APPLICATION NO.	FILING DATE	FIRST NAMED INVENTOR	ATTORNEY DOCKET NO.	CONFIRMATION NO.
10/088,539	03/19/2002	Veikko Kankaanpaa	540-016.2	6927

Office Action Summary	Application No. 10/088,539	Applicant(s) VEIKKO KANKAANPAA	
	Examiner José A. Fortuna	Art Unit 1731

10. The prior art made of record and not relied upon is considered pertinent to applicant's disclosure in the art of "Method of Dispersing a Pulp."

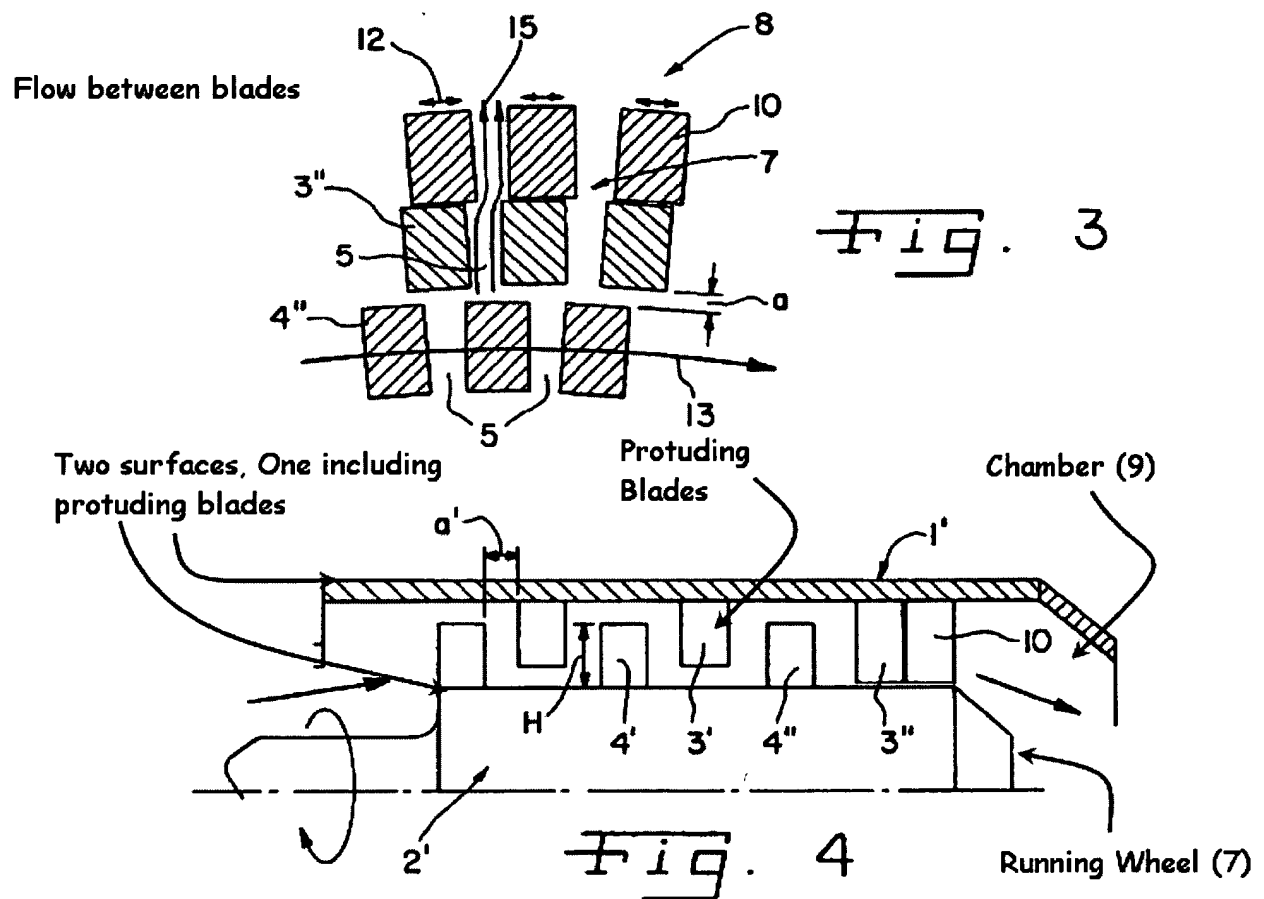
Schneid et al. teach a method of dispersing pulp containing solid material and a liquid phase in a dispersing device (Figures 1, 4) wherein the dispersing takes place in a narrow opening (a) between rotating protruding blades having conical surfaces (3 3', 3'') and (4, 4' 4'') on the rotor (2) and stator (1). Figure 4 shows a running wheel, which would rotate the blades and acts as a pump to pump the dispersed material out of the dispersing device, see below.

Note that the running wheel protrudes within the outlet chamber; see figures above.
